Telephony Refresh Project

Request for Proposal: Questions & Responses

August 24, 2011

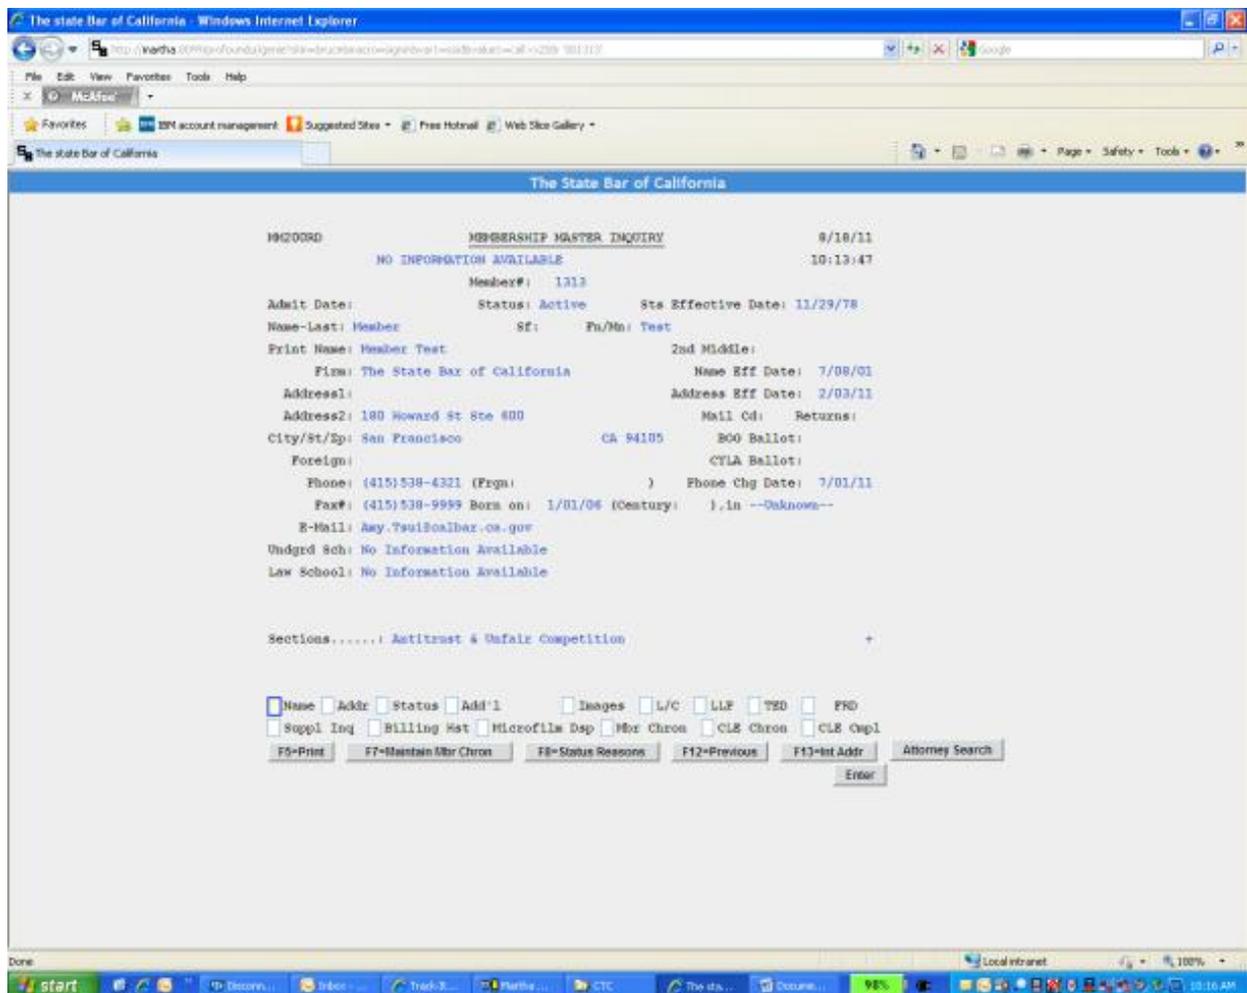
- a) Could you please provide a list of requirements of what the Call/Contact Center is expected to provide when Logic Genie is launched?**

- d) Could you please provide screen shots of what the Call/Contact Center needs to display?**

Screen Pop displaying a Member Record – see sample below.

See the sample below.

Steps for Screen Pop to Display Member Record:

- a. *Check for caller id match in any of the following (see attached list of Member Data Elements):*
Public Telephone Number
Public Foreign Telephone Number
Private Telephone Number
Private Foreign Telephone Number

- b. *If not found present error message and prompt caller for Member Bar Number*

- c. *Present attached sample screen using the member number as a variable in the following link example:*
